Mark B. Bezilla
Site Vice President724-682-5234
Fax: 724-643-8069December 2, 2002
L-02-115U. S. Nuclear Regulatory Commission
Attention: Document Control Desk
Washington, DC 20555-0001**Subject: Beaver Valley Power Station, Unit No. 1 and No. 2
BV-1 Docket No. 50-334, License No. DPR-66
BV-2 Docket No. 50-412, License No. NPF-73
Response to a Request for Additional Information in Support of
License Amendment Requests Nos. 300 and 172**

Attachment A to L-02-115
Responses to November 22, 2002, RAI Section 1.0 - Enclosure 2

NRC Request for Additional Information

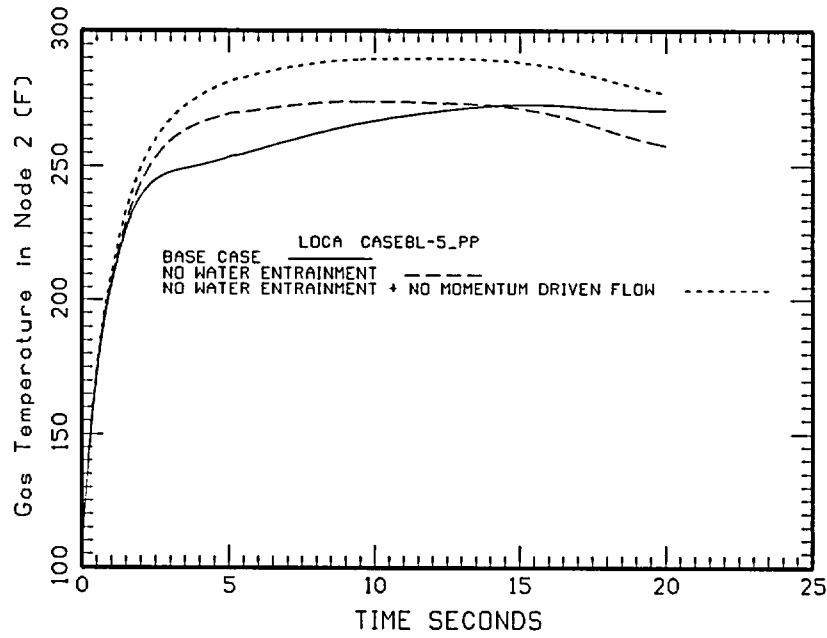
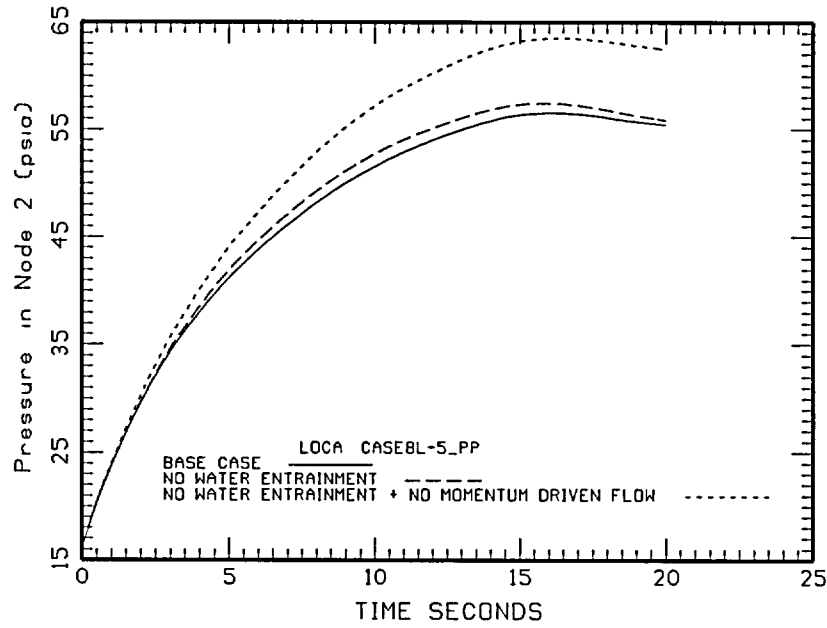
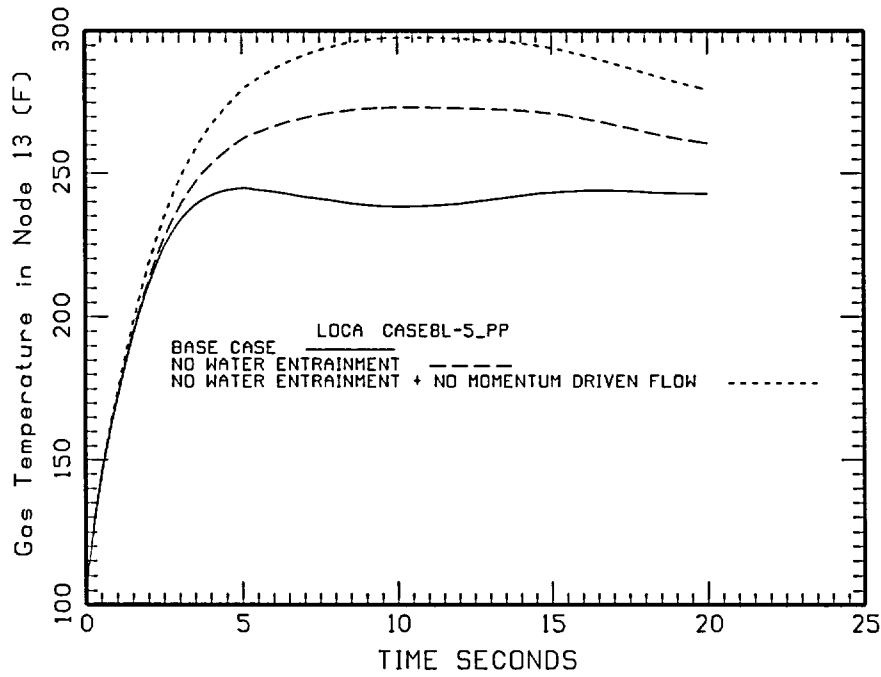
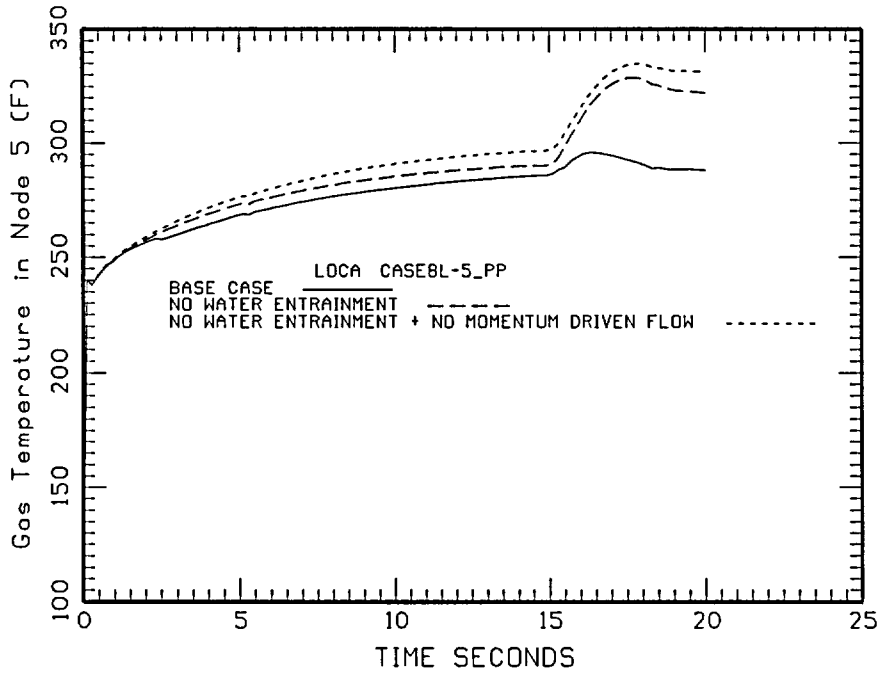
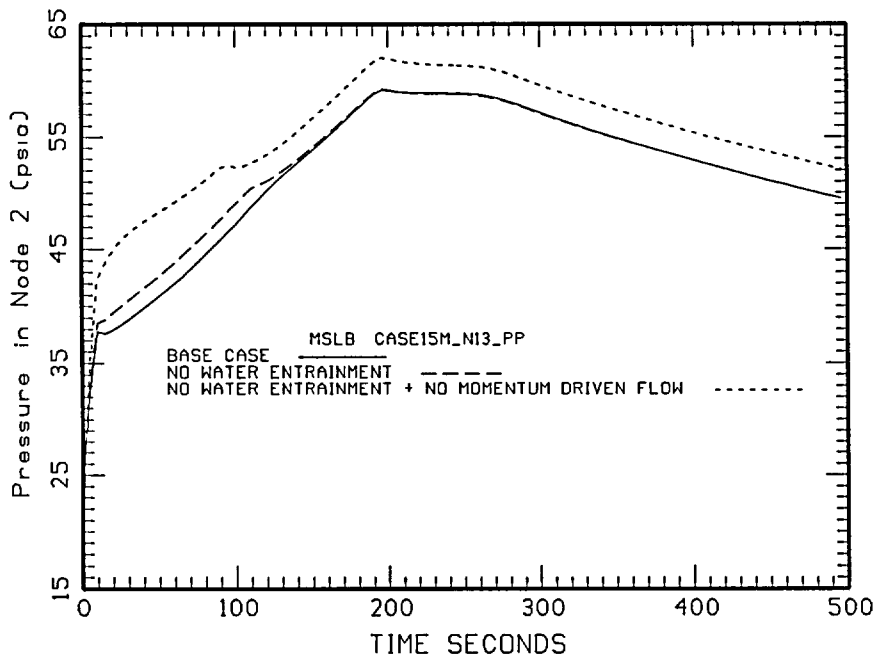
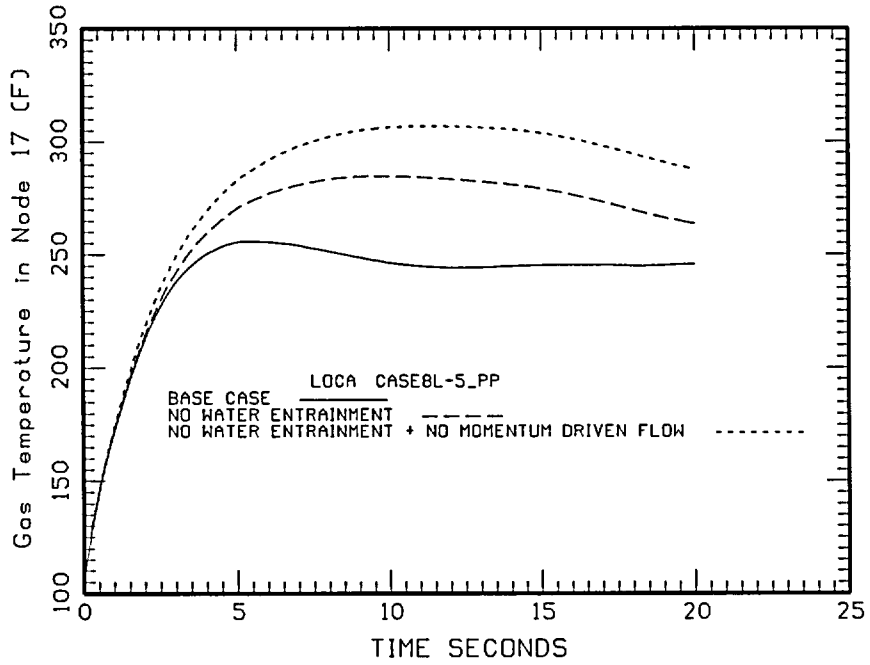
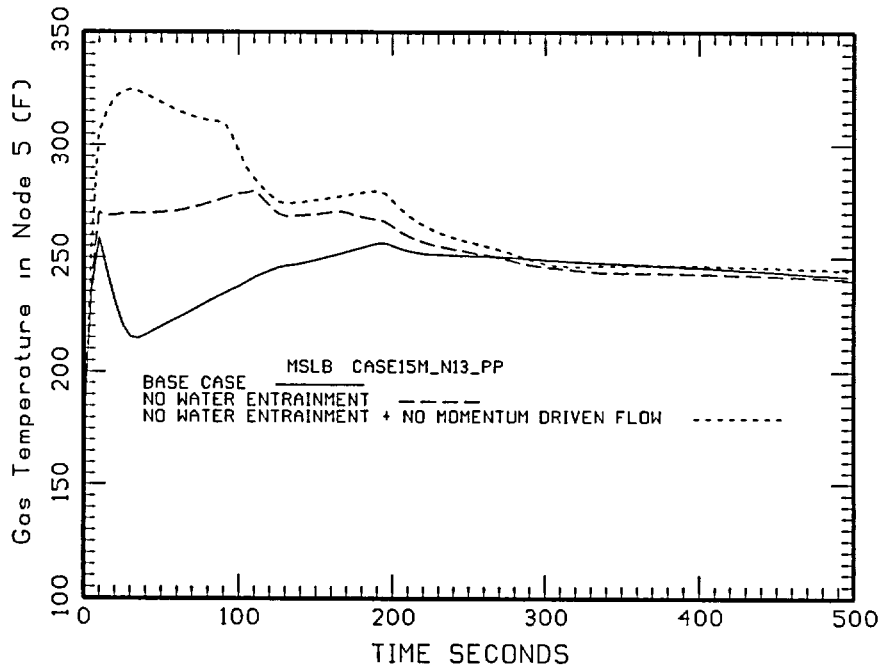
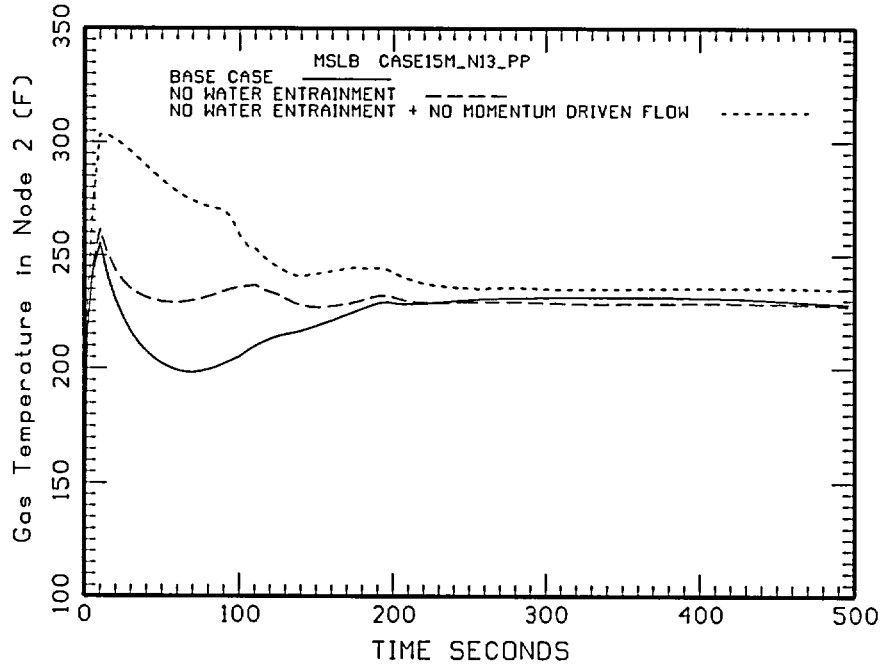
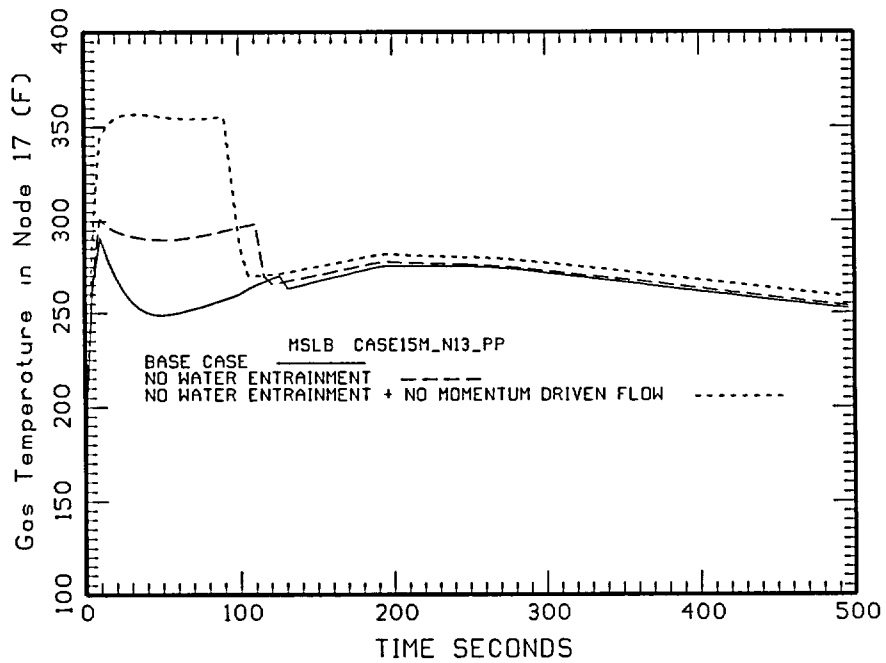
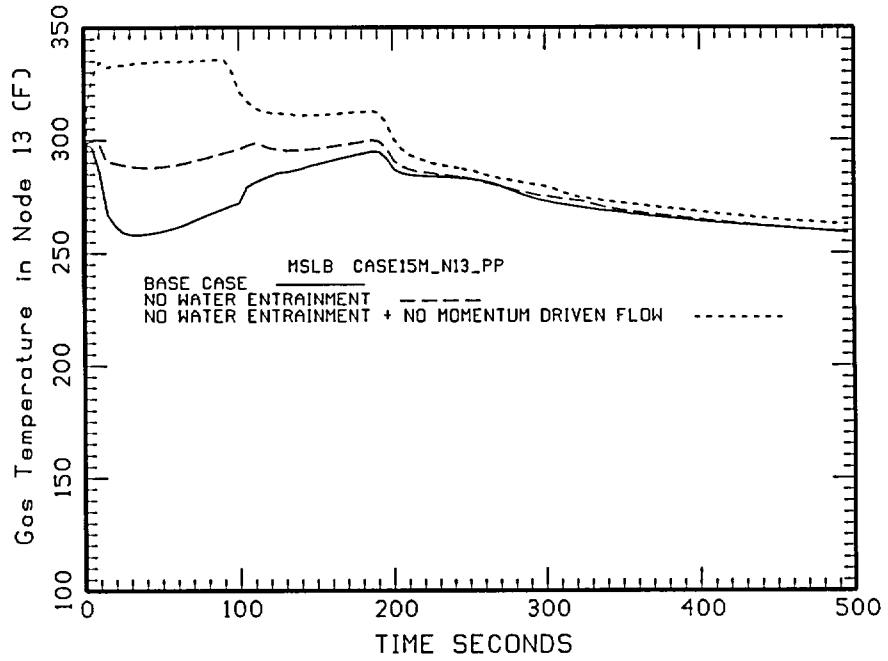
Item 1.1.4. What amounts of peak pressure and temperature margins are associated with the new MAAP5 models for a) forced condensation using the momentum-driven velocity, b) nodalization, and c) water entrainment? Discuss for main steam line break (MSLB) and loss-of-coolant accident (LOCA).

The impact on the nodal pressure and temperature histories of water entrainment and momentum-driven flow are illustrated in the following family of plots (see Figures 1 through 5) for both the large break LOCA (case 8L-5_PP) and the MSLB (case 15M_N13_PP).

For the large break LOCA the peak pressure increases about one psi when water entrainment model is not activated and about 8 psi when neither the water entrainment model nor the momentum-driven flow model are activated. Higher gas temperatures are also illustrated for these two sensitivity cases.

For the MSLB the peak pressure is essentially unchanged when the water entrainment model is not activated but it increases about 3 psi when neither the water entrainment nor the momentum-driven flow models are not activated. A similar trend is demonstrated for the peak gas temperature such that the gas temperature is only significantly increased (about 45°F) when neither water entrainment nor momentum-driven flow are credited.

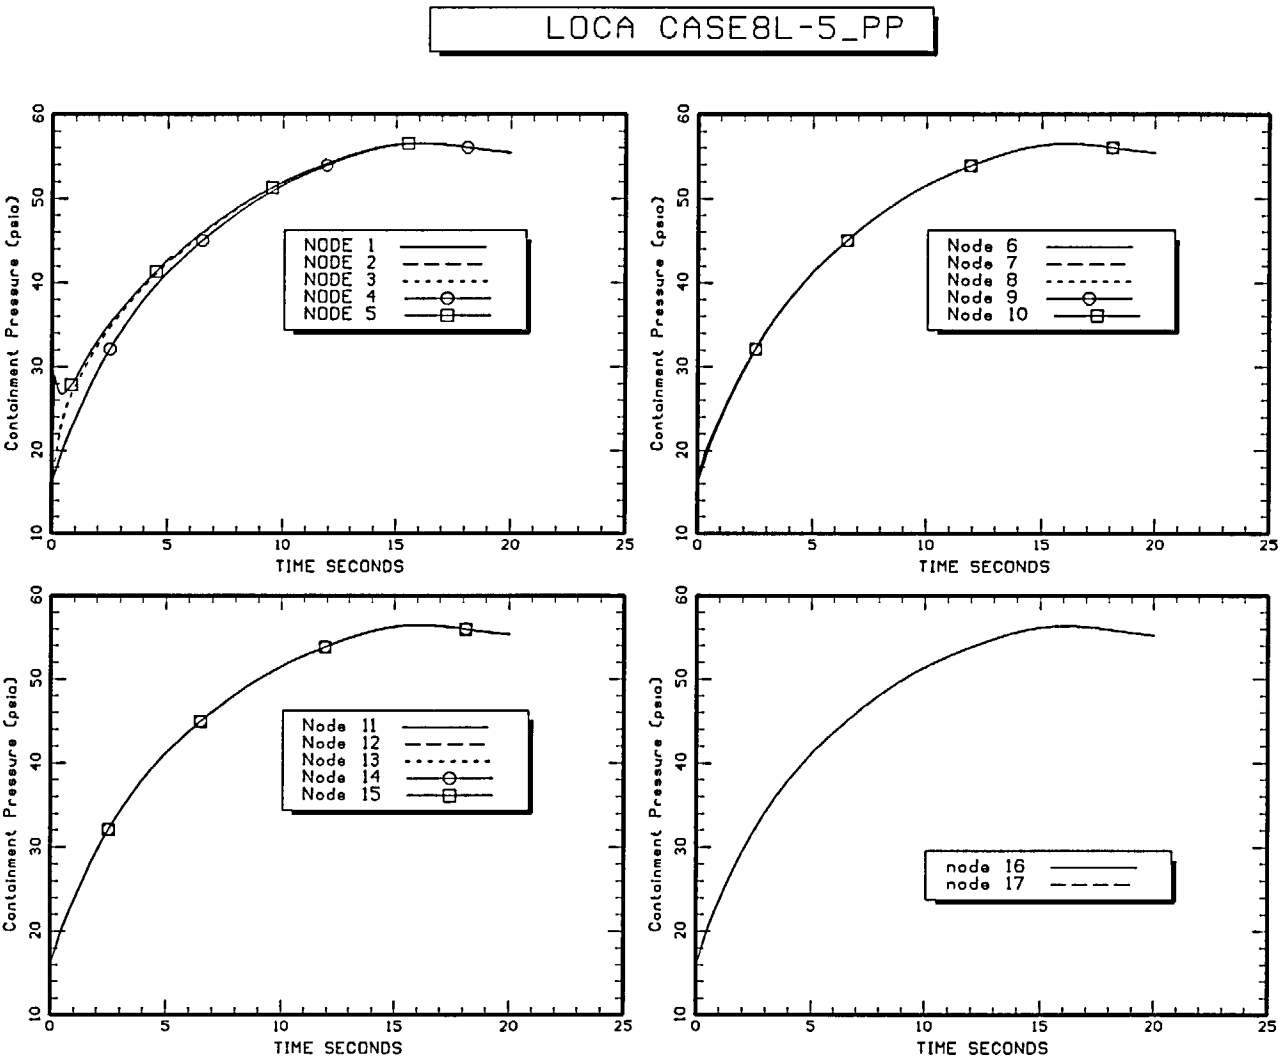
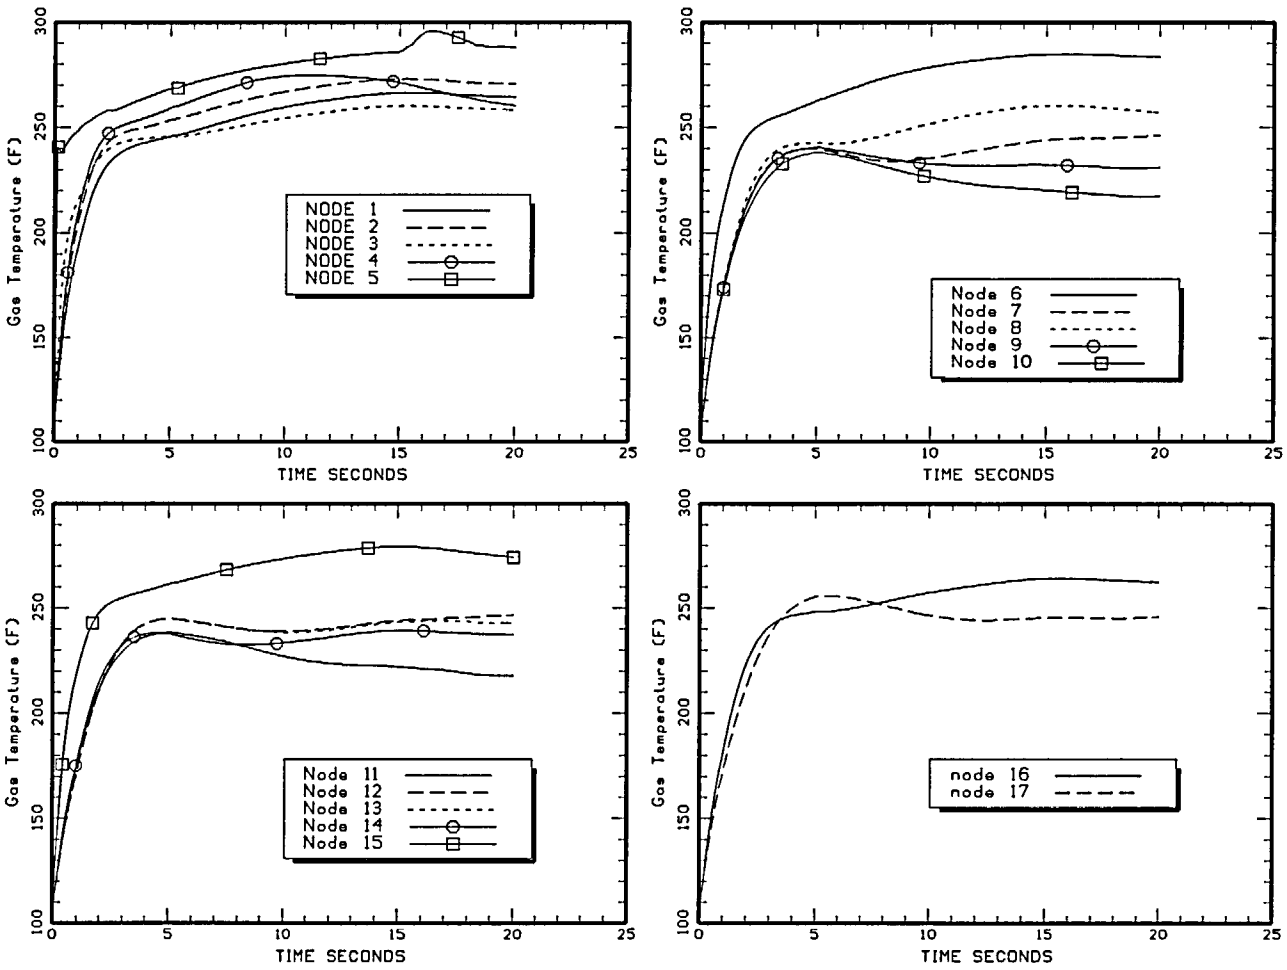
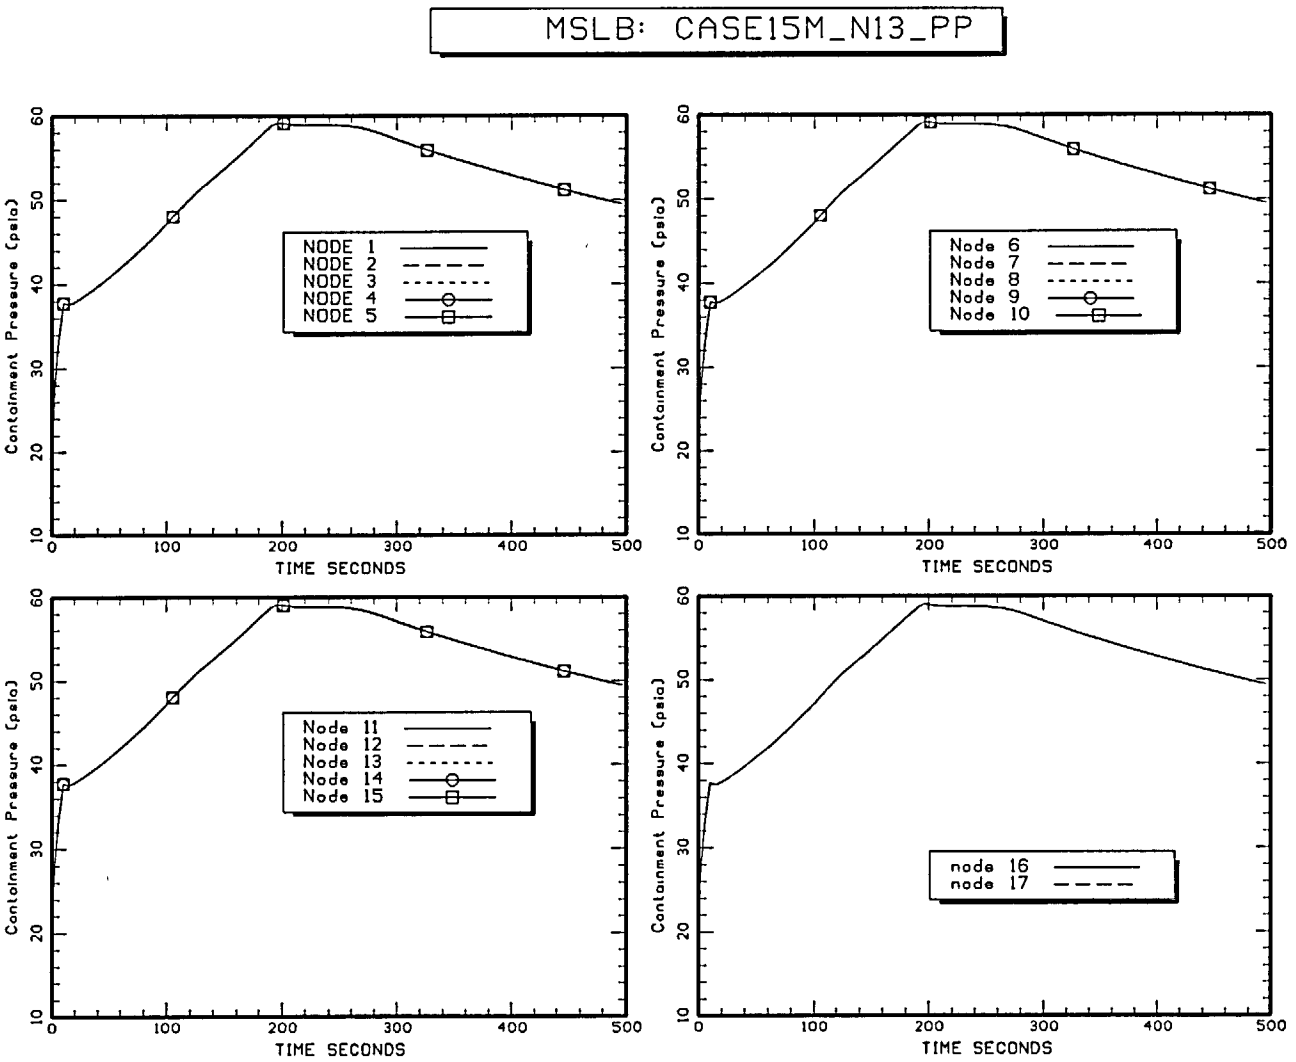
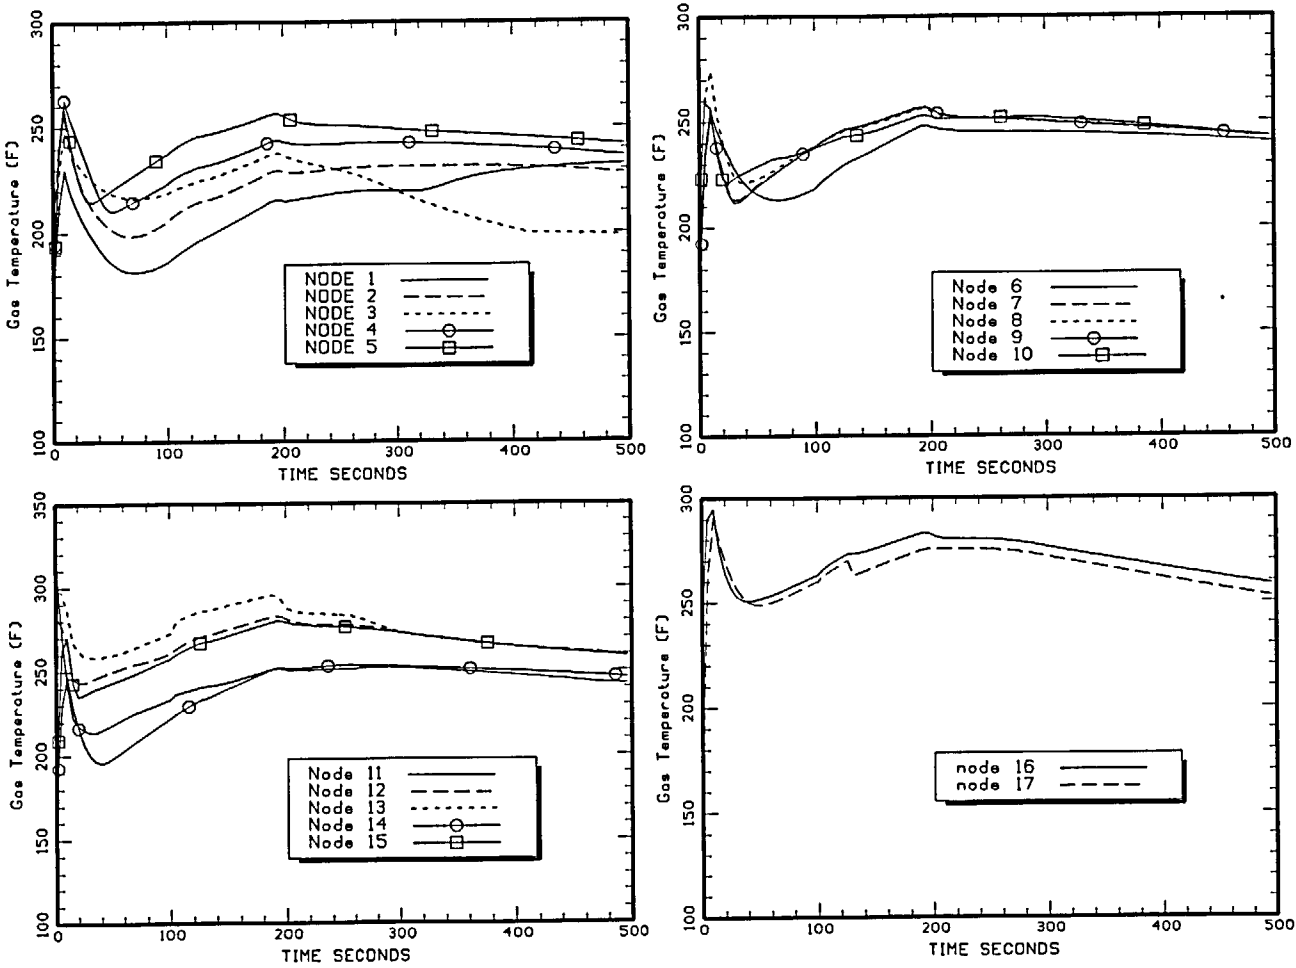
Item 1.2.1. Show MAAP pressure and temperature time history profiles for MSLB (e.g., 15MN13-1.4) and LOCA representative calculations. Label temperature profiles by compartment number (include all compartments).

The pressure and temperature time history profiles for the representative large LOCA double ended hot leg break (case 8L-5_PP) and the representative MSLB (case 15M_N13_PP) are provided for all seventeen containment nodes in Figures 8 through 11.
